June 28, 2007

Re: Post-Hearing Submission – Waterside Mall
Modification to First-Stage PUD Approval and
Application for Second-Stage PUD
Zoning Commission Case No. 02-38A

A

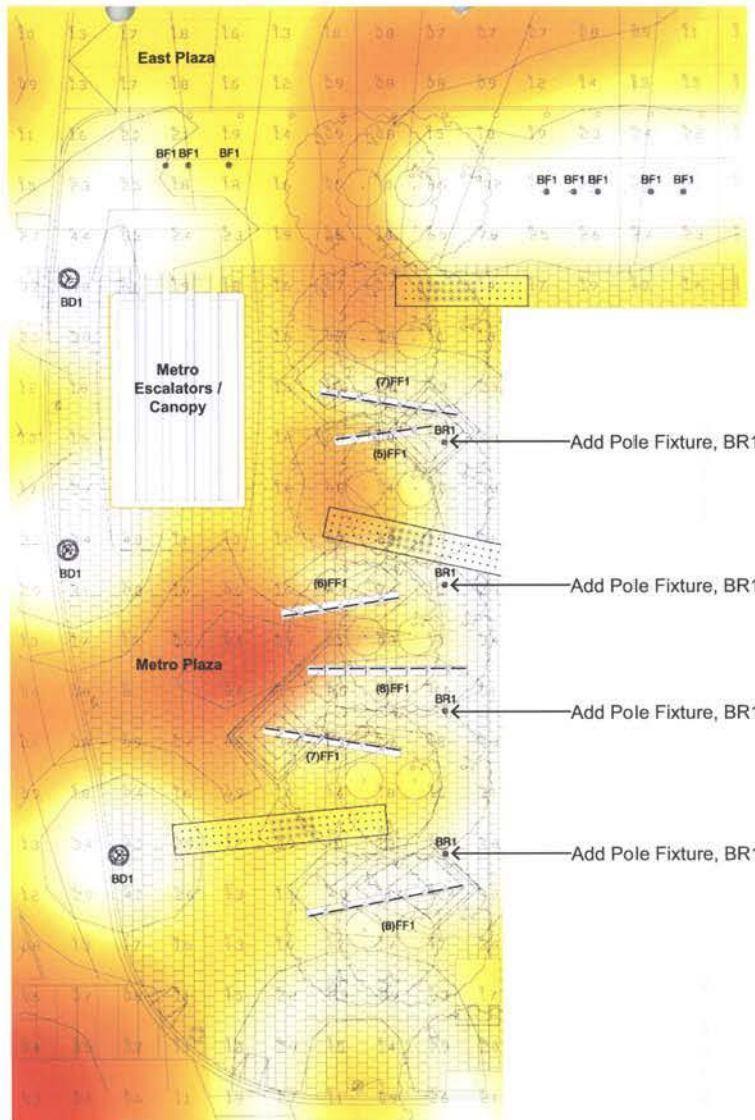
The Zoning Commission raised a question as to whether the amount of lighting in the Metro Plaza would provide sufficient illumination. As a result, the Applicant re-evaluated the lighting plan for the Metro Plaza and proposes the addition of four new pole fixtures along the eastern edge of the plaza to supplement the illumination levels in the space. The additional fixtures will provide an average

of 1.0 to 2.0 footcandles of illumination below the bosque of trees while maintaining the dramatic lighting effect that fixtures integrated into the benches and water features are intended to provide. A plan showing the revised lighting is attached as Tab A.

The Applicant proposes to add four new pole fixtures along the eastern edge of the plaza to supplement the illumination levels in the space. The additional fixtures will provide an average of 1.0 to 2.0 footcandles of illumination below the bosque of trees while maintaining the dramatic lighting effect that the fixtures integrated into the benches and waterfeatures are intended to provide.
